RESPONSES TO COMMENTS

# San Francisco International Airport Shoreline Protection Program

San Francisco Planning  
Case No. **2020-004398ENV**

*Date:* May 17, 2023  
*Case No.:* **2020-004398ENV**  
*Project Title:* **San Francisco International Airport Shoreline Protection Program**  
*To:* Members of the Planning Commission and Interested Parties  
*From:* Lisa Gibson, Environmental Review Officer  
*Re:* Attached Responses to Comments on Draft Environmental Impact Report for the San Francisco International Airport Shoreline Protection Program (Planning Department File No. 2020-004398ENV)

**FIGURE 2-25**  
**RUNWAY 19L LIGHTING TRESTLE PLAN AND SECTION**

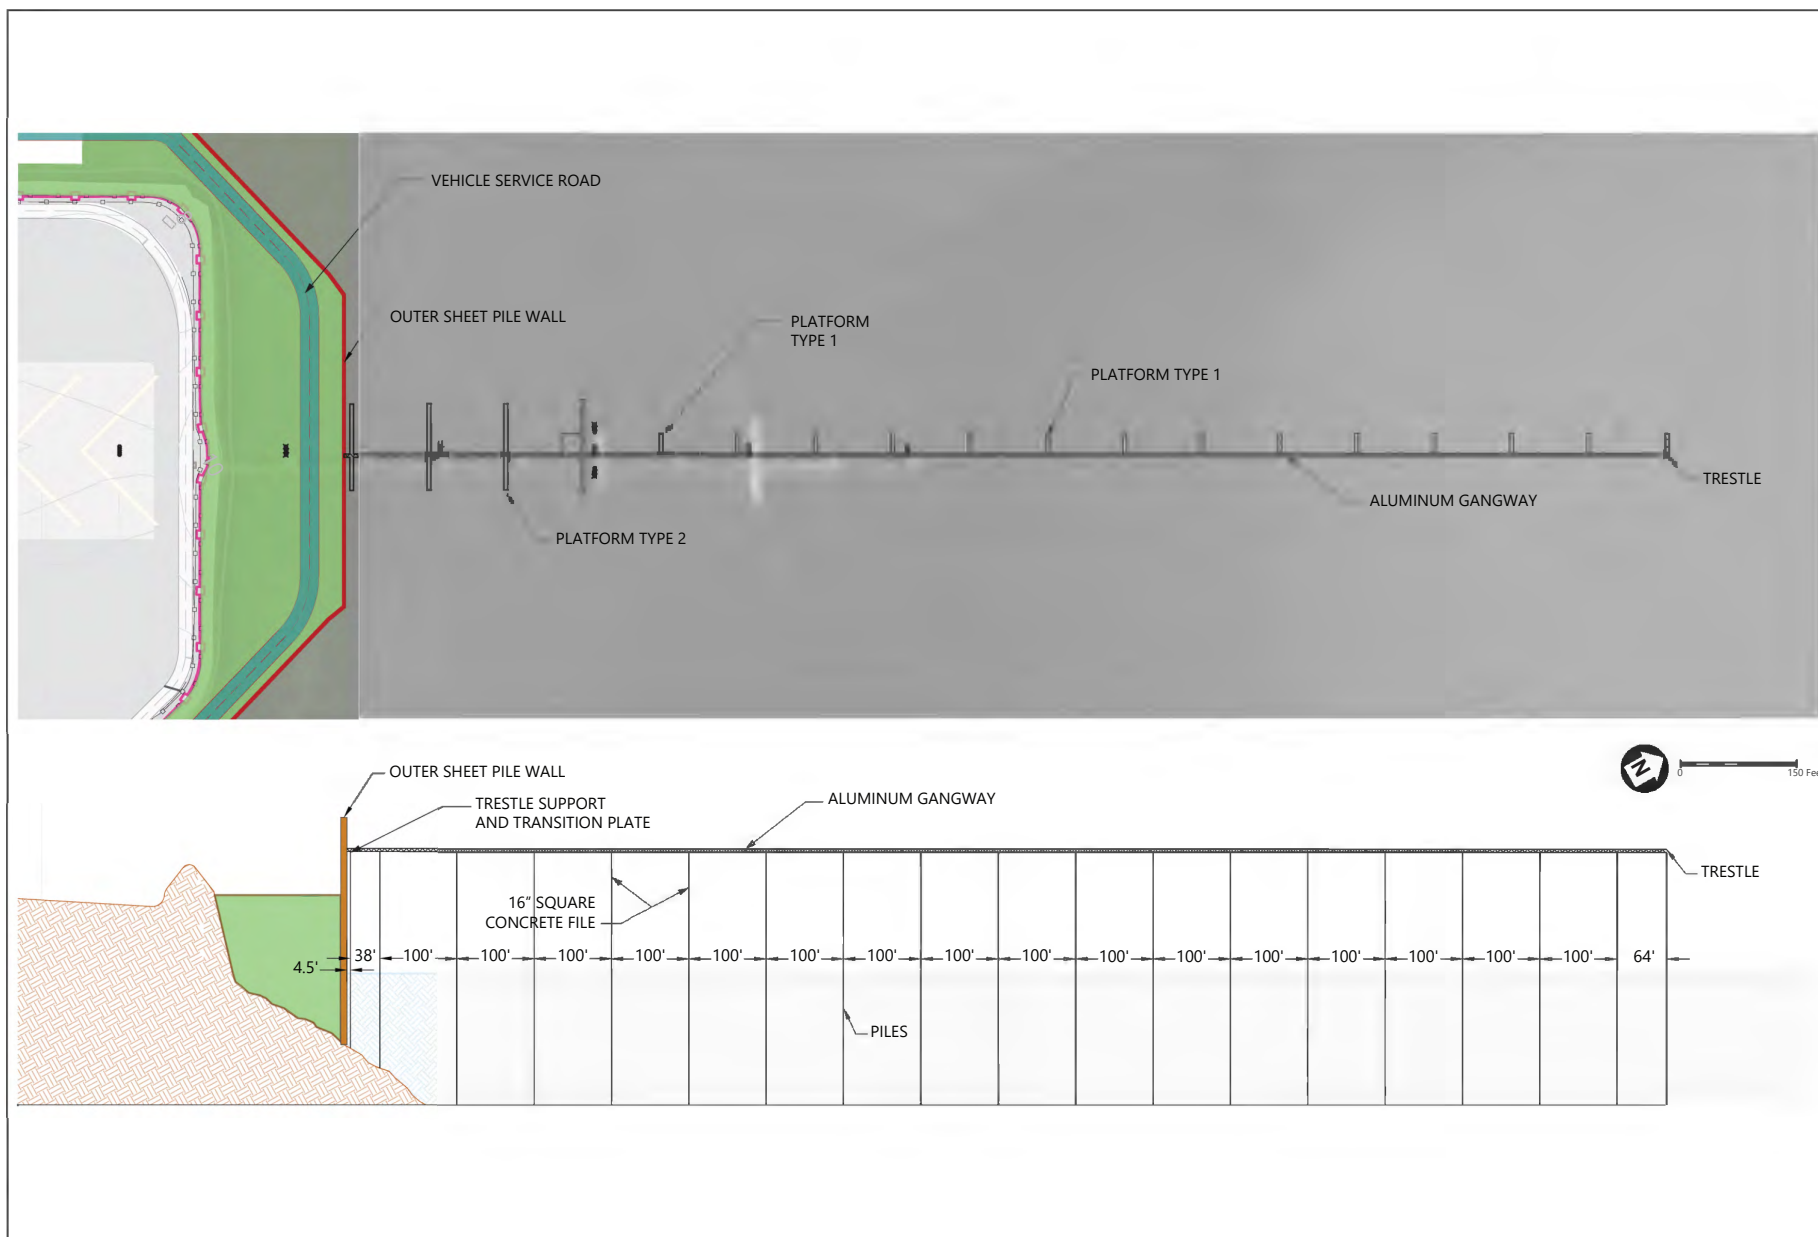
To accommodate construction of Reach 7, the existing approach lighting trestle at the end of Runway 19L would be demolished, and a new lighting trestle would be constructed. Reconstructing the lighting trestle would be necessary to ensure that the proposed shoreline protection system would not obstruct the navigation light plane from the approach lights, which facilitates aircraft arrivals on Runway 19L. Therefore, the proposed project would construct a new approximately 4.5-foot-taller, 1,000-foot longer lighting trestle in approximately the same location as the existing lighting trestle, remove the existing approach lights, demolish the existing lighting trestle, and remove the existing wood piles in the bay that support the lighting trestle (see **Figure 2-25**). The Airport assumes temporary interruption of operations on Runway 19L would occur during construction of the lighting trestle and testing of the reinstalled approach lighting system.

To accommodate construction of Reach 7, the existing approach lighting trestle at the end of Runway 19L would be demolished, and a new lighting trestle would be constructed. Reconstructing the lighting trestle would be necessary to ensure that the proposed shoreline protection system would not obstruct the navigation light plane from the approach lights, which facilitates aircraft arrivals on Runway 19L. Therefore, the proposed project would construct a new approximately 4.5-foot-taller, 1,000-foot longer lighting trestle in approximately the same location as the existing lighting trestle, remove the existing approach lights, demolish the existing lighting trestle, and remove the existing wood piles in the bay that support the lighting trestle (see **Figure 2-25**). The Airport assumes temporary interruption of operations on Runway 19L would occur during construction of the lighting trestle and testing of the reinstalled approach lighting system.

- Figure 2-25 has been revised to show the extended lighting trestle; the revised figure is provided in RTC Chapter 5, Draft EIR Revisions.

- Figure 2-25 has been revised to show the extended lighting trestle.
